Consents Hearing 16 December 2020

Gore District Council – APP-20202268

Council Reference: APP-20202268

**Re: Request for Further Information under Section 92(1) of the Resource Management Act 1991 –
Application for Longford Bridge Shared Pathway.**

Figure 1: Abutment shelf and beam soffit levels

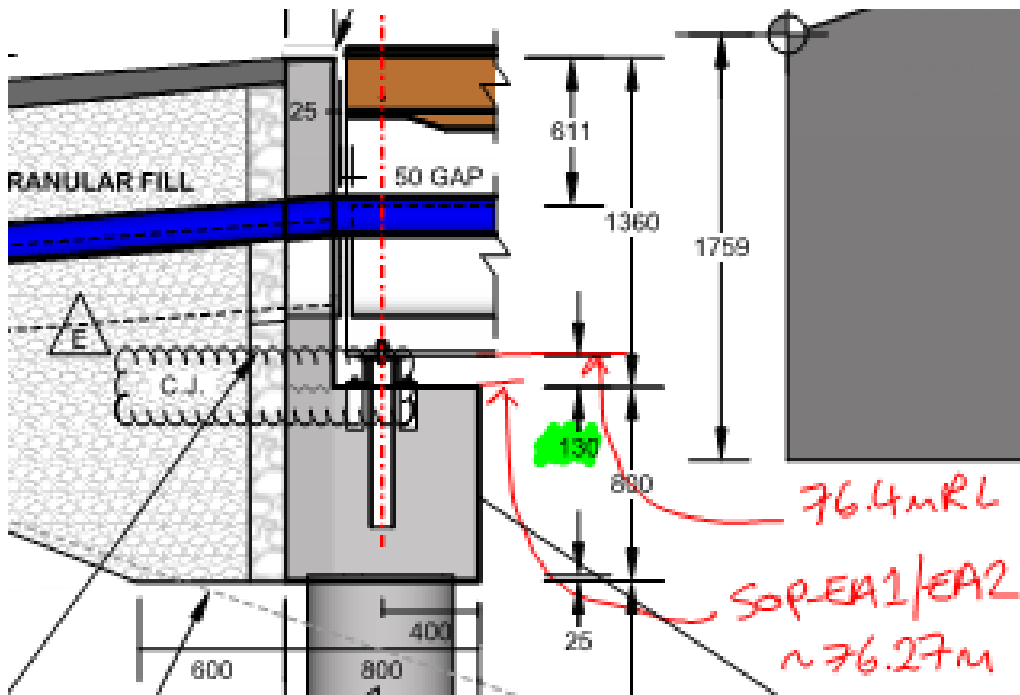
"Confirmation of the eastern abutment construction level. The design diagram shows the soffit at a level of 76.4m (plan S101), but the abutment set out plan shows a level 76.269m (SOP-EA1) plan S111. I am requesting this information because Council's Engineer has some concerns relating to the inconsistent construction levels of the eastern abutment."

The abutment shelf level on S111 is not the same thing as the beam soffit level as shown on S101. Between these two levels is the abutment bearing of circa 130mm (see Figure 1 below). This is not an inconsistency.
